**Committee date 14/05/2024**

**Application No:** 24/23/00016

**Proposal:** Approval of the details of appearance, landscaping, layout and scale, for the erection of 40no. dwellings.

**Site Location:** Land To The North Of, Old Bristol Road, East Brent, Highbridge, Somerset, TA9

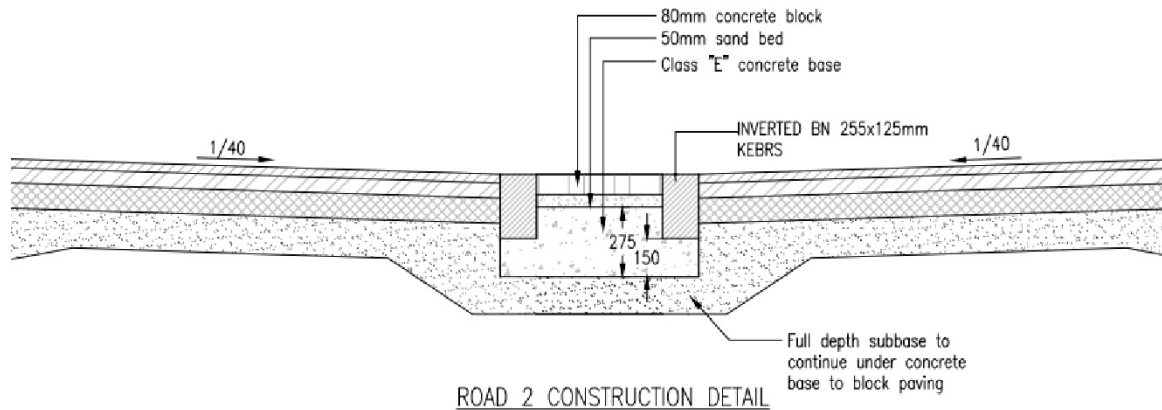
**During the committee meeting there was a lot of concern and debate regarding the potential for surface water flooding and concerns regarding the drainage proposal for the site. The Lead Local Flood Authority were provided with a drainage statement, engineering layout, micro drainage calculations and an exceedance route plan.**

**The site has been designed with a pumped drainage solution. Further confirmation was sought from the LLFA to justify this approach. The applicant confirmed the mean summer water level in the rhyne is 4.80m AOD and the outfall cannot be lower than this. The**

**minimum finished flood level agreed by the Environment Agency is 5.93m AOD. Wessex Water require all surface water pipes offered for adoption to meet the minimum self-cleansing velocity set out in Design Construction Guidance (DCG). Therefore, the surface water network shown on drawing 2244-100-P utilises the minimum acceptable gradients and the minimum acceptable cover. Based on the above the outfall into the attenuation basin can be no higher than 3.450m AOD, 1.35m below the outfall level.**

**The 2019 Flood Risk Assessment (FRA) confirmed a minimum FFL of 6.45m AOD, which reflected EA's original response (17/08/2018) to the application. The EA later amended the minimum FFL to 5.93m AOD which was secured as condition 26 of the Appeal decision (9/12/2021).**

**The original FRA was not updated to reflect the latest comments from the EA nor were detailed hydraulic calculations included. The approved FRA also utilised a climate change allowance of 40% as was current at the time of approval.**
